Work Order ID 97742

Item Name: Energy Attenuating Floor Provisions

DART SERVICE INSTRUCTION

TO AMEND INSTALLATION INSTRUCTIONS IIN-D350-689 REV. B
AND INSTRUCTIONS FOR CONTINUED AIRWORTHINESS ICA-D350-689 REV. 1
REF. TCCA STC: SH02-33
REF. FAA STC: SR01620NY
REF. EASA STC: EASA.IM.R.S.01453
REF. TCA STC: 2005S03-09

FIGURE 1: UPDATES TO CROSS SECTIONS F-F AND M-M
 With reference to Figures 5 and 7 of IIN-D350-689
 (Figures 25-5 and 25-7 of ICA-D350-689)

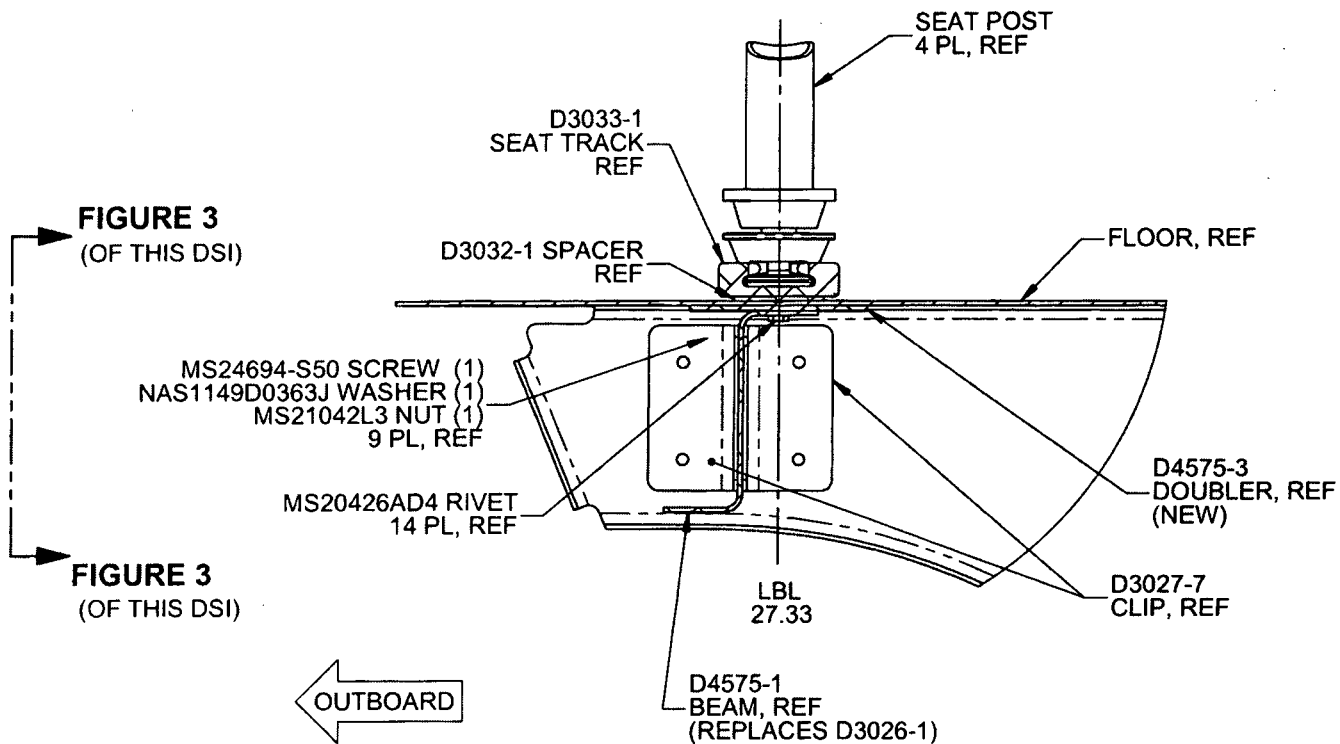
If there is an existing stringer at LBL 27.33, it will need to be removed from that location. Locate D4575-1 Beam, D4575-3 Doubler, and D3032-1 Spacer as shown in Figure 1 of this Service Instruction. Transfer drill existing holes from the aircraft floor to the D4575-1 Beam, D4575-3 Doubler, and D3032-1 Spacer. Ensure 1.0" to 1.5" rivet pitch and add additional holes if required. If there is no existing stringer, locate D4575-1 Beam, D4575-3 Doubler, and D3032-1 Spacer as shown in Figure 1 of this Service Instruction and drill Ø0.128" holes on a 1.0" to 1.5" pitch.

Counter sink holes in the D3032-1 Spacer for MS20426AD4 rivets. Install D4575-1 Beam, D4575-3 Doubler, and D3032-1 Spacer to floor using MS20426AD4 rivets.

FIGURE 2: UPDATES TO FIGURE 21 (IIN-D350-689) AND 25-21 (ICA-D350-689)
 With reference to Figures 19 and 20 of IIN-D350-689
 (Figures 25-19 and 25-20 of ICA-D350-689)

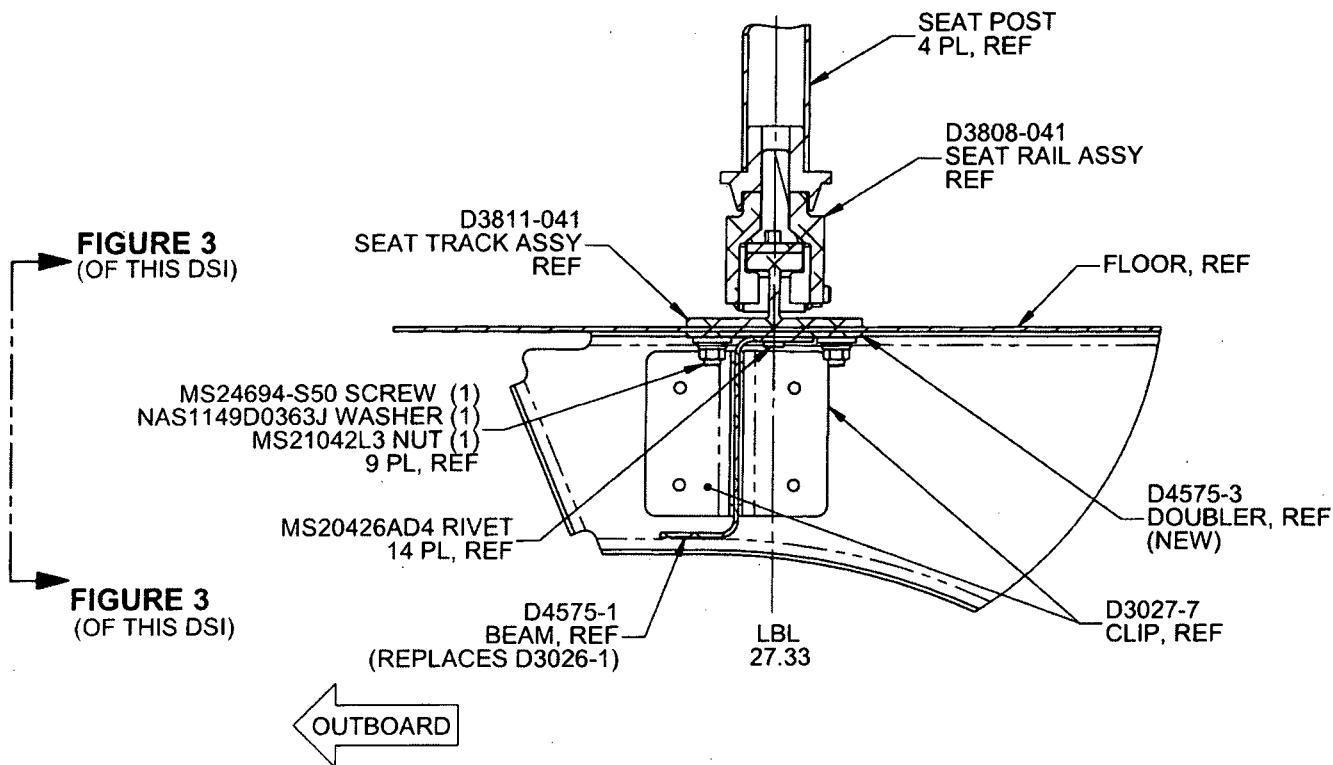
If there is an existing stringer at LBL 27.33, it will need to be removed from that location. Locate D4575-1 Beam and D4575-3 Doubler as shown in Figure 2 of this Service Instruction. Transfer drill existing holes from the aircraft floor to the D4575-1 Beam and D4575-3 Doubler. Ensure 1.0" to 1.5" rivet pitch and add additional holes if required. If there is no existing stringer, locate D4575-1 Beam and D4575-3 Doubler as shown in Figure 1 of this Service Instruction and drill Ø0.128" holes on a 1.0" to 1.5" pitch.

Attach D4575-1 Beam and D4575-3 Doubler to floor using qty (14) MS20426AD4 rivets.

FIGURE 3: RELIEFS ON D4575-1/-3
(ONLY D4575-1/-3 SHOWN FOR CLARITY)
VIEW LOOKING INBOARD

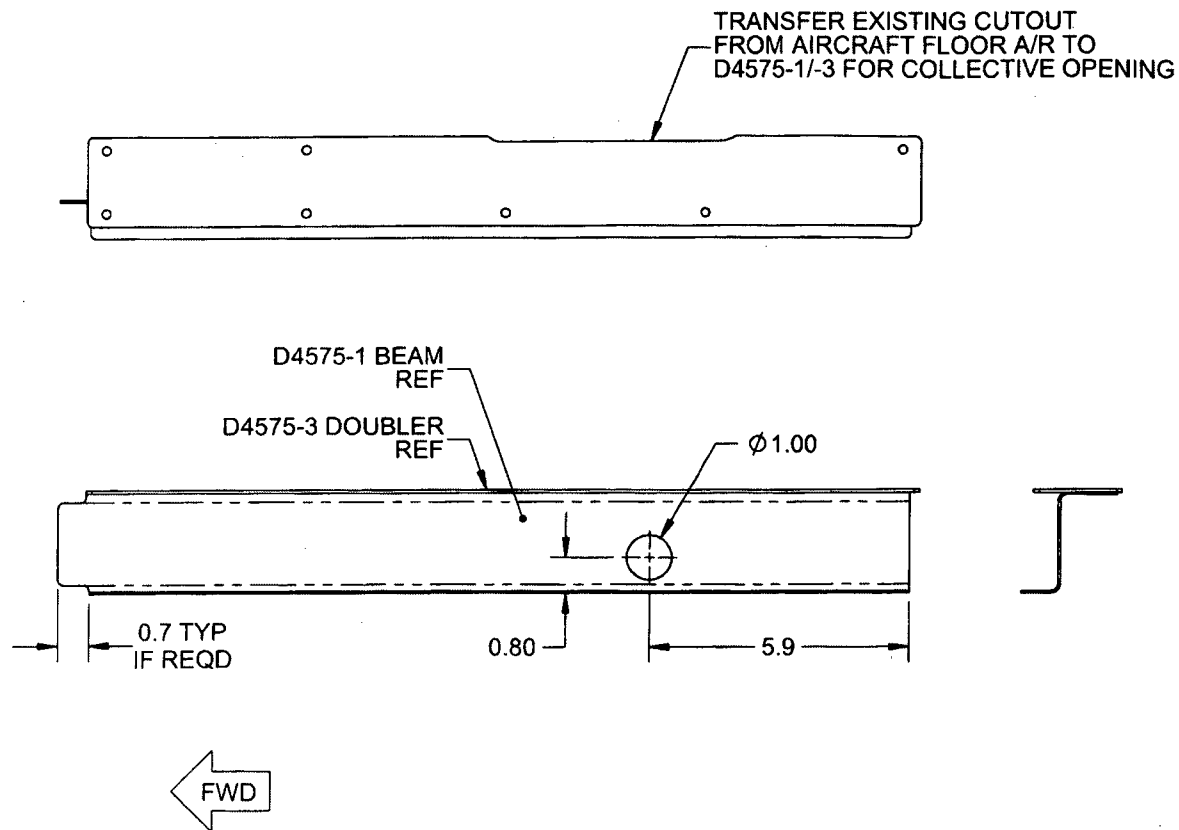
Note: Drill a Ø1.00" (Ø25.4 mm) hole in the D4575-1 Beam to clear extension tube of collective and cutout as required for clearance of collective opening and fwd bulkhead as shown in Figure 3 of this Service Instruction.

Note: Drill a Ø1.00" (Ø25.4 mm) hole in the D4575-1 Beam to clear extension tube of collective and cutout as required for clearance of collective opening and fwd bulkhead as shown in Figure 3 of this Service Instruction.
